Intersection ID: N/A	Main Street: COVENTRY_COURT_LN	Cross Street: CASTLE_ABBEY_LN	Location:	SW
ADA ID: 610899F3710D	Ramp Type: ParaDiag	Initial Pass/Fail: Fail	Overall Compliance: No	Severity Score: 13.75

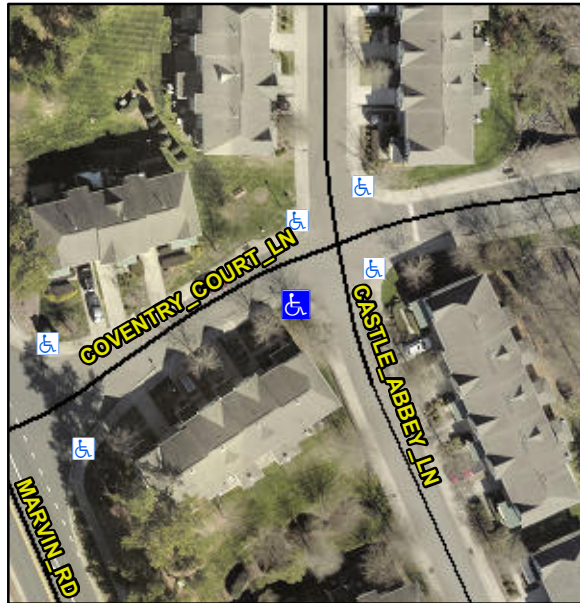
LT RP < 5%

R304.5.3, R304.3.2

Compliance	Description	Data	Compliance	Description	Data
N/A	Ramp Length LT (in)	32.0	N/A	Ramp Length RT (in)	39.0
Yes	Ramp Width LT (in)	60.0	Yes	Ramp Width RT (in)	60.0
Yes	Ramp Slope LT (%)	1.6	No	Ramp Slope RT (%)	9.1
No	Ramp XSlope LT (%)	2.3	No	Ramp XSlope RT (%)	3.0
N/A	Landing Length (in)	N/A	N/A	DWS Provided?	N/A
N/A	Landing Width (in)	N/A	N/A	DWS Contrast?	N/A
N/A	Landing Slope (%)	N/A	N/A	DWS Length (in)	N/A
N/A	Landing X Slope (%)	N/A	N/A	DWS Full Width?	N/A
N/A	Landing Curb? (Y/N)	N/A	N/A	DWS Offset (in)	N/A
N/A	Shared Landing?	N/A			
N/A	Gutter Ponding?	N/A	N/A	Gutter Slope (%)	N/A
N/A	Gutter Lip Ht (in)	N/A	N/A	Gutter X Slope (%)	N/A
N/A	Painted X Walk1?	No	N/A	Painted X Walk2?	No
	X Walk 1 Direction	To E		X Walk 2 Direction	To N
N/A	X Walk 1 Width (in)	N/A	N/A	X Walk 2 Width (in)	N/A
	X Walk 1 Slope (%)	1.6		X Walk 2 Slope (%)	4.1
	X Walk 1 X Slope (%)	4.4		X Walk 2 X Slope (%)	2.7
N/A	Ramp inside XWalk1?	N/A	N/A	Ramp inside XWalk2?	N/A

Remove & Replace Curb Ramp With Two New Directional Ramps or Equivalent.
